si 881219-14 e

Ref.: EM 2003 TV

Fault: 50 Hz hum when the EM 2003 TV receives an RF-carrier without modulation.

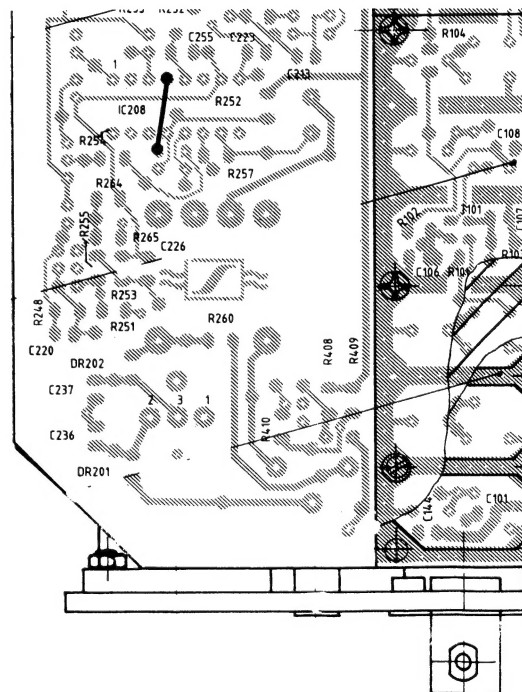
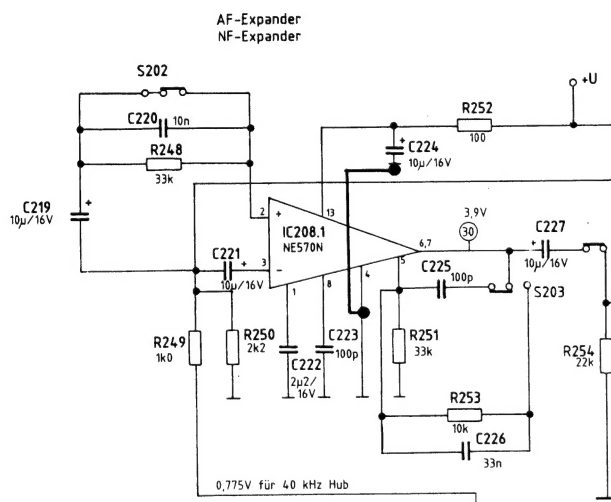
Cause: Insufficient ground connection at HiDyn-IC

Remedy: Connect ground connection of IC 208.1 to ground connection of IC 224. This will reduce the hum by 6 dB.
